ADDENDUM 2

BID TITLE: File No.150-25 Secondary Site Improvements-Cycle J

SECONDARY SITE IMPROVEMENTS – CYCLE J – FILE NO. 150-25

REVISIONS		CITY OF CLEVELAND	
NO.	DATE	CLEVELAND DIVISION OF WATER	
		DEPARTMENT OF PUBLIC UTILITIES	
		CLEVELAND, OHIO	
		SUBJECT Independence Drip Edge	
		N/A	
		SCALE N/A	
		DATE 4/14/25	
		SHEET 1 OF 1

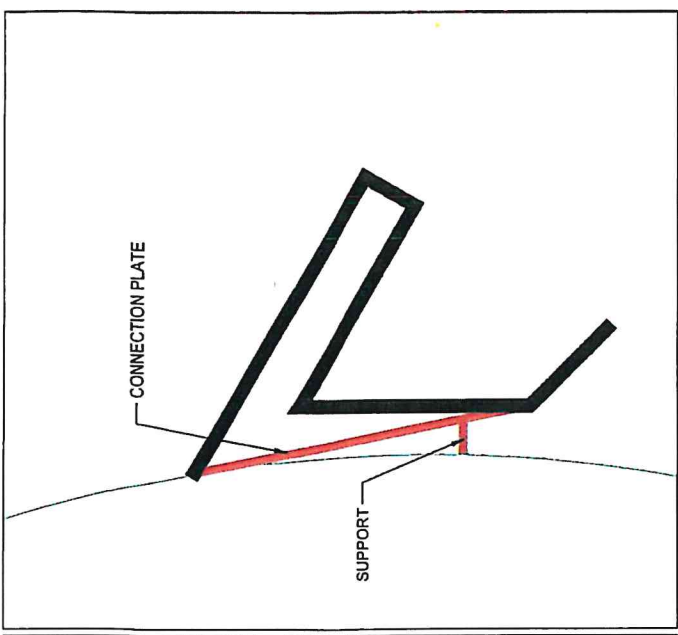
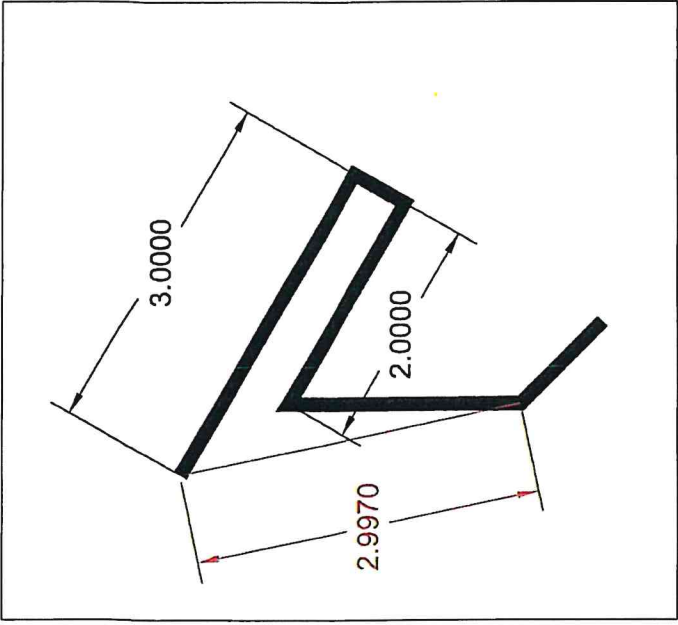
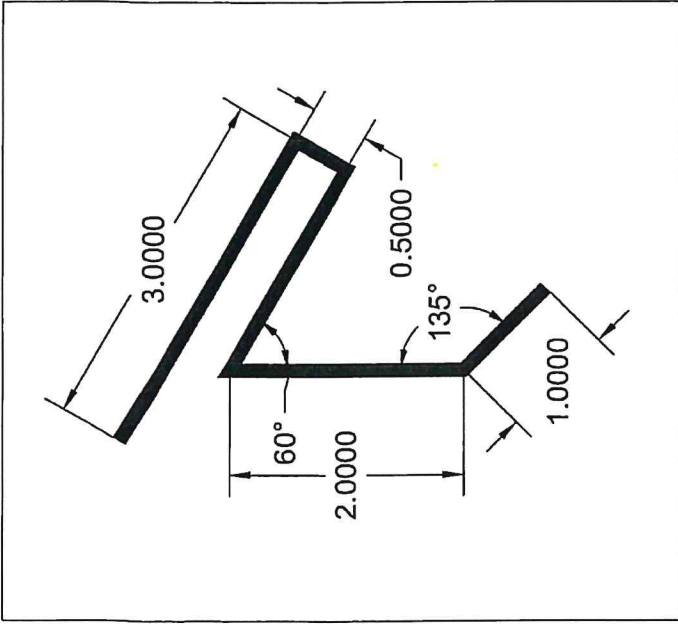
14. Independence: Please provide a detail and location of the drip edge referenced in Bid Item 37

Answer: See attached drawing. Drip edge will be around the entire tank.

1. All units of measurement are to be assumed as Inches unless otherwise stated.
2. Thickness is too assumed the same thickness of the Indy Edge
3. The width of the Drip Edge is to be 16 inches
4. Support length is TBD once the drip edge is complete and ready for attachment.
